SAFETY SYSTEM DIGITAL PLATFORM -MELTAC-

MUAP-07005-NP(R910)

JEXU-1012-1002-NP(R~~9~~10)

Figure 4.1-18 Mechanism of WDT (CPU Module) WDT Architecture of MELTAC

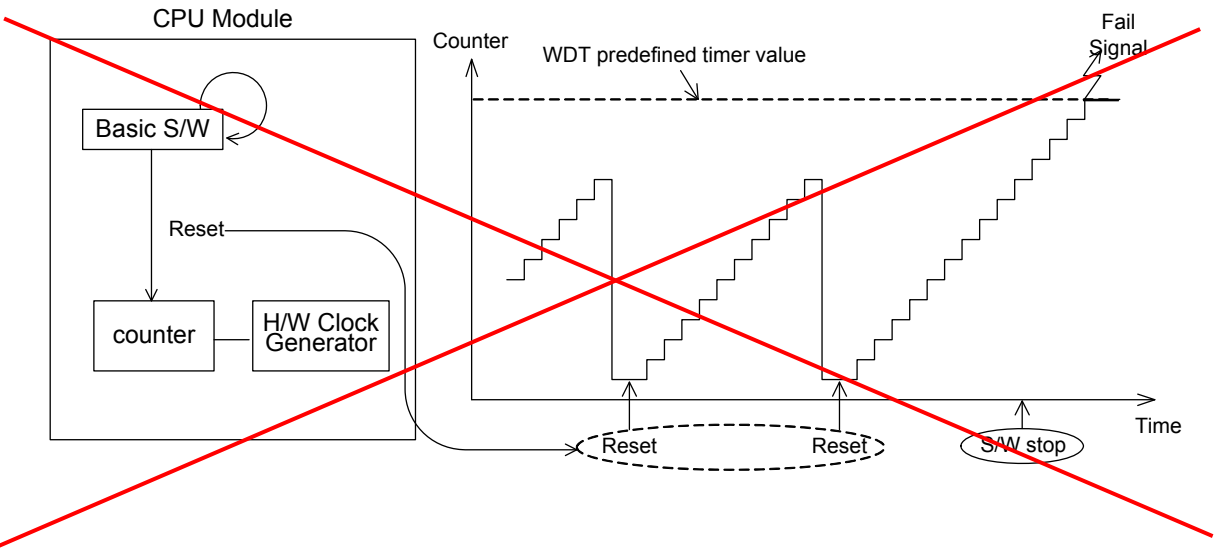
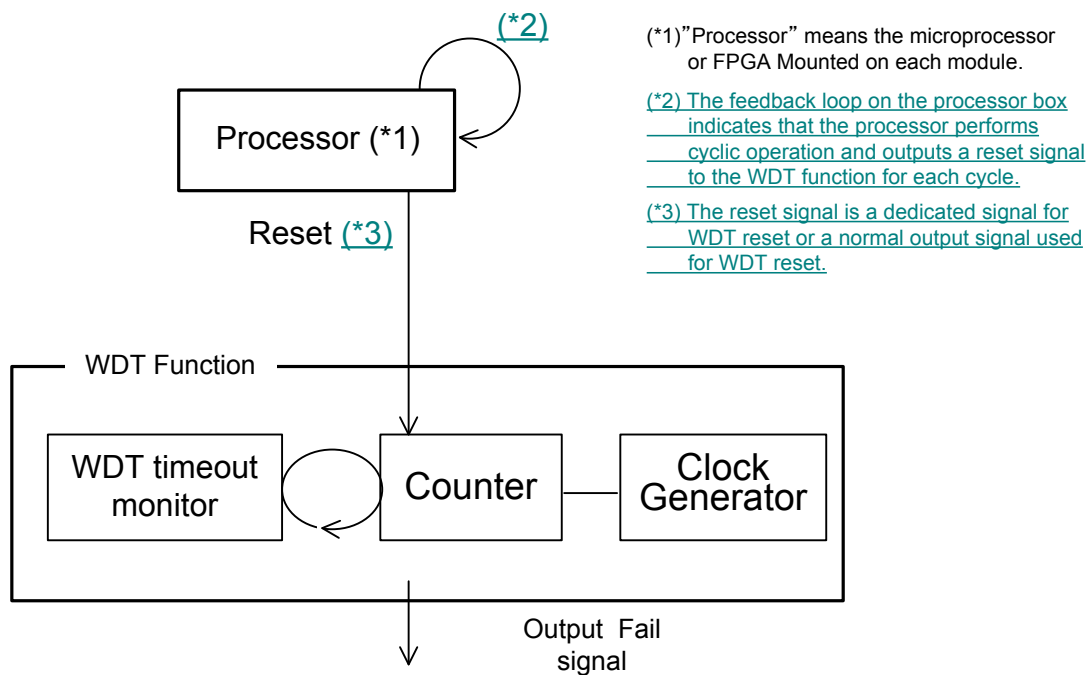
(1)The WDT consists of a counter with a hardware clock generator, and predefined timer value (for WDT timeout), a WDT timeout monitor, and a clock generator, which are independent of the processor which executes safety functions. (See Figure 4.1-18) The WDT is both mounted on a device and applies a software architecture which is different from the microprocessor in the CPU Module that performs safety functions.

- (2) After initialization, the timer starts to count up. (See Figure 4.1-19)
- (3) The WDT maintains normal operation through monitoring of the counter status to confirm that the counter value is periodically (i.e. for each operation cycle) reset by the processor. ~~The basic software resets the timer to zero at regular intervals (i.e. for each operation cycle).~~ (See Figure 4.1-19)
- (4) If the ~~basic software~~ processor does not reset the ~~WDT counter value~~ within a predefined timer value, ~~then a WDT timeout occurs. the WDT times out and the controller transitions to a Failure mode (see Section 4.1.5) with an alarm indication.~~ The independence between the safety functions and the WDT functions is credited for separated modules.
